**S12A AMENDMENT OF PLAN APPLICATION  
APPROVED NGAU TAM MEI  
OUTLINE ZONING PLAN NO. S/YL-NTM/12**

**PROPOSED REZONING FROM "R(C)" TO "G/IC"  
FOR A PROPOSED "SOCIAL WELFARE FACILITIES"  
(RESIDENTIAL CARE HOMES FOR THE ELDERLY)  
(RCHE)**

**AT LOT 4823 IN D.D.104, 81 SAN TAM ROAD,  
SAN TIN, N.T.**

**FURTHER INFORMATION  
OCT 2022**

Green Coverage:  
Primary Zone (15m above mean street level):

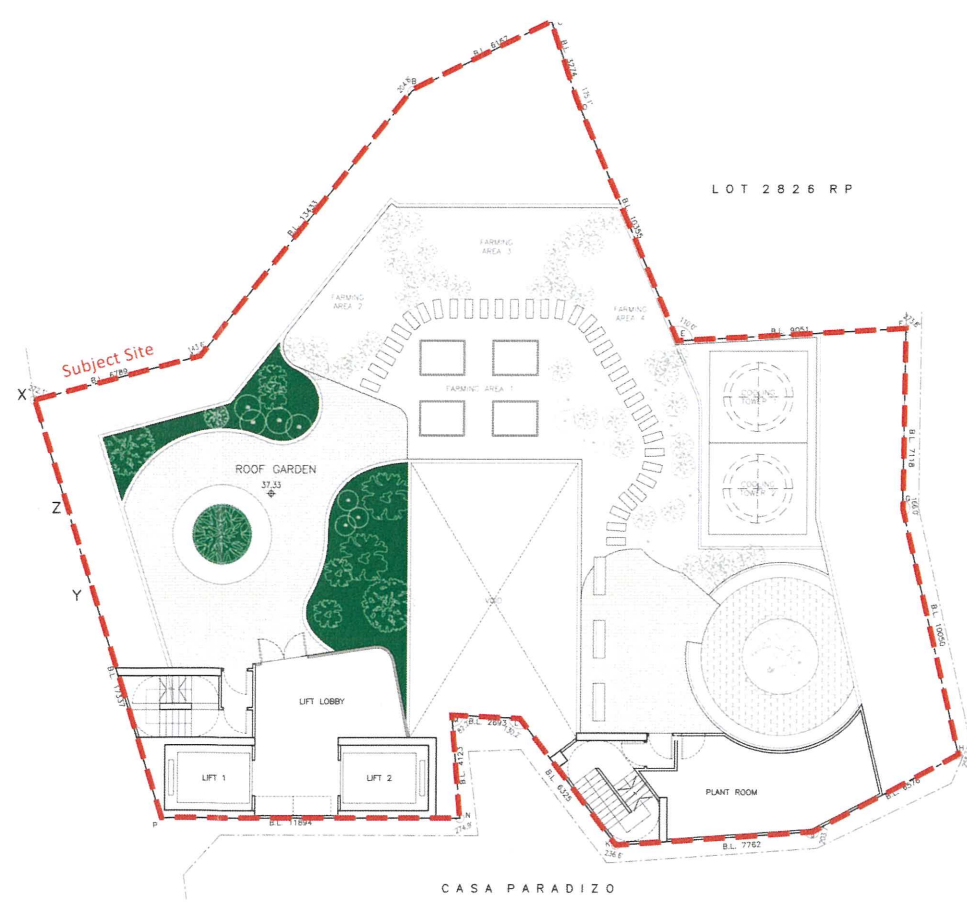
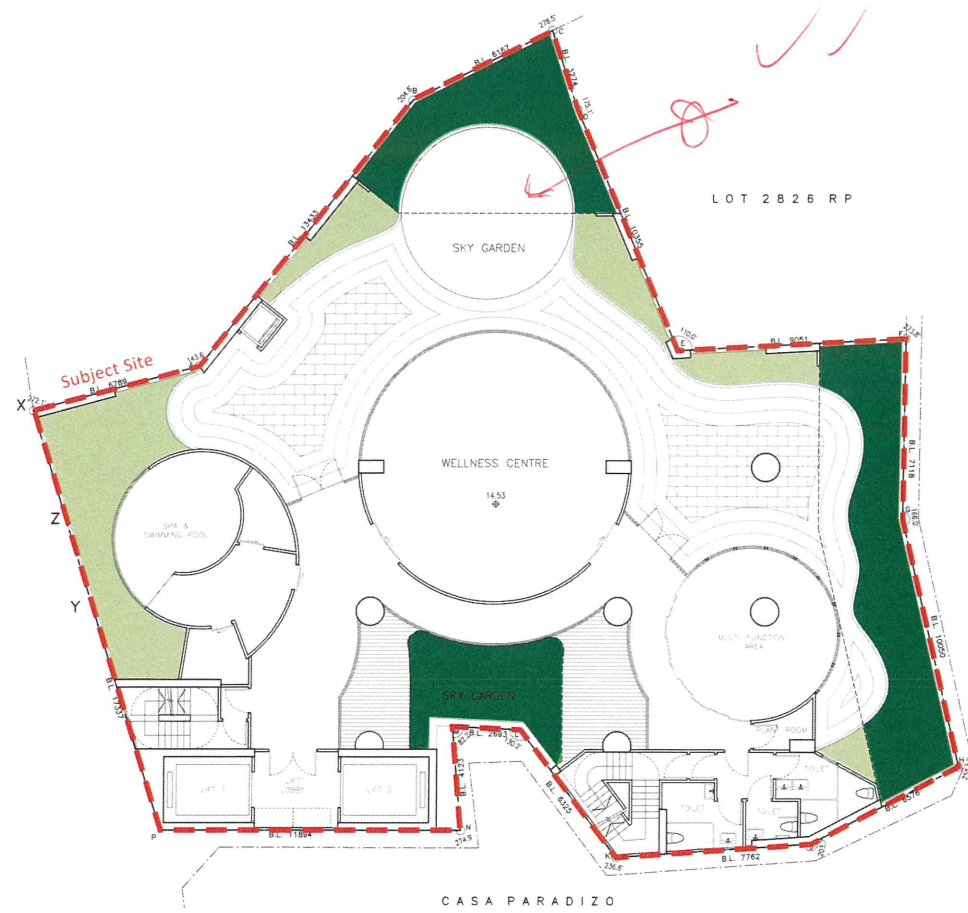
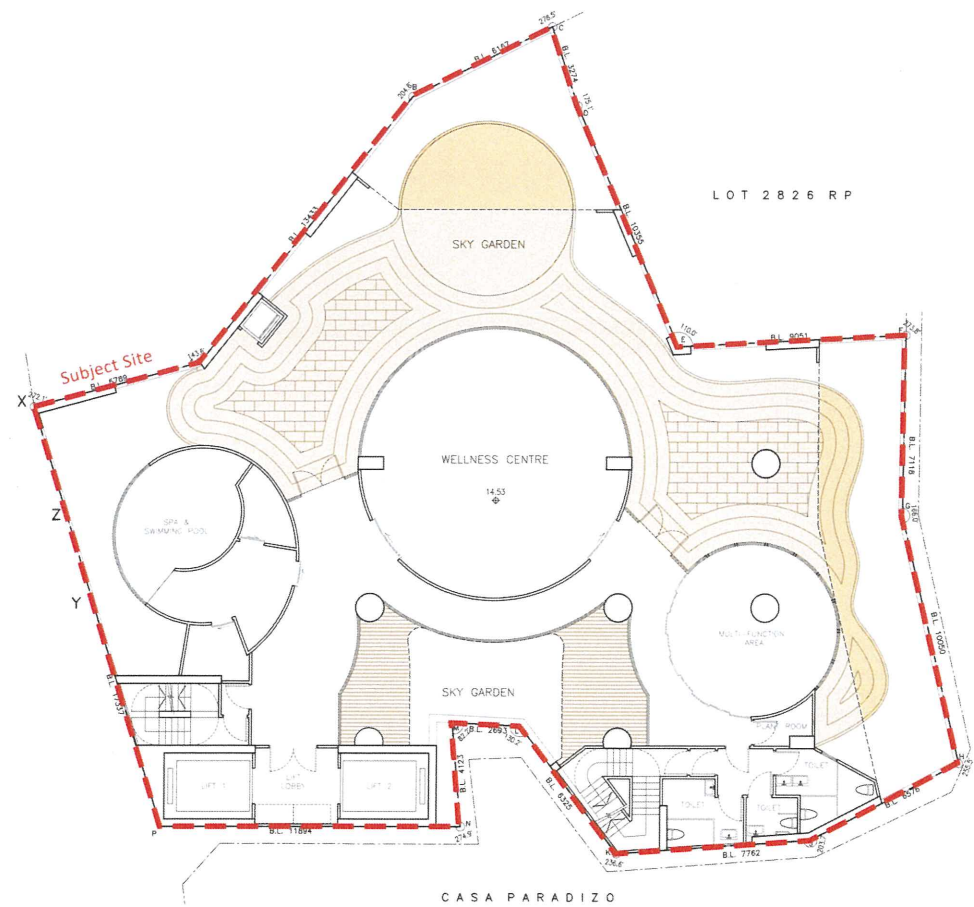
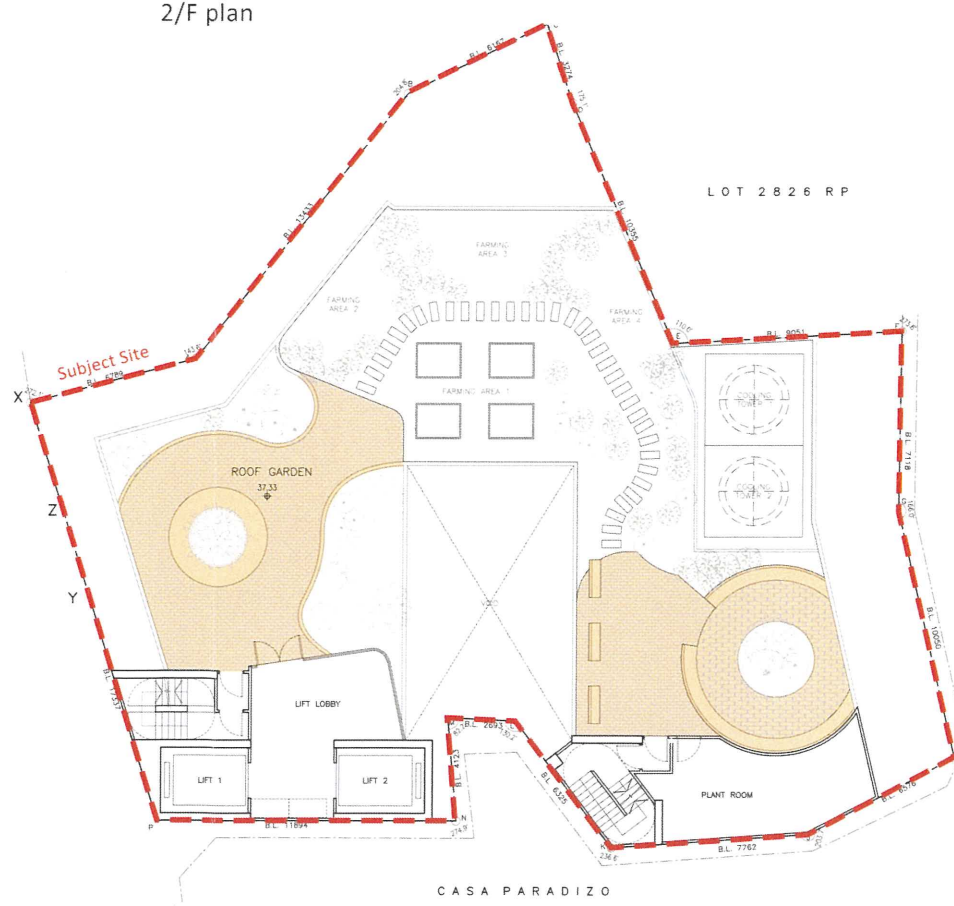
Comments	Response
(x) Figure 14 “Green Coverage Calculation” <ul style="list-style-type: none"> <li>● The provision of greenery coverage has not been indicated on this figure.</li> </ul>	Revised as per Figure 14 Rev. B.
